Access Compliance Report Public Rights-of-Way (Curb Ramps)

Main Street: N/A Cross Street: ROSSMOOR_CENTER_WAY Location: SW

ADA ID: RPRK211208114639 Ramp Type: Type 1 - Perpendicular Diagonal Initial Pass/Fail: Fail Overall Compliance: No Severity Score: 2

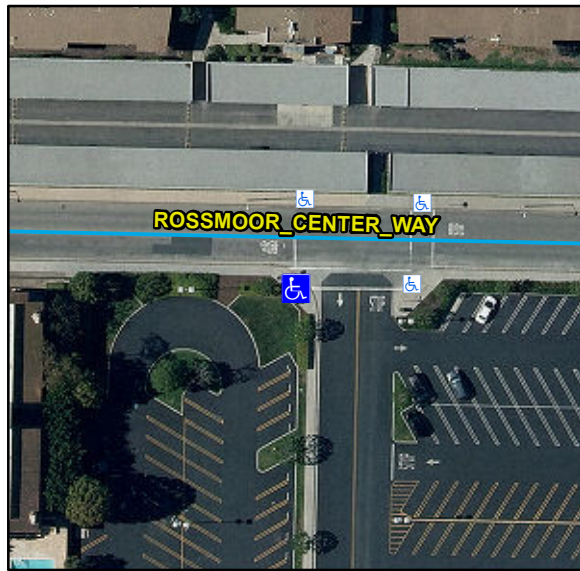
R204.3, R304.5.3, R302.7.2, STD 1115

Remove & Replace Curb Ramp With Two New Directional Ramps or Equivalent. Grind Gutter Lip.
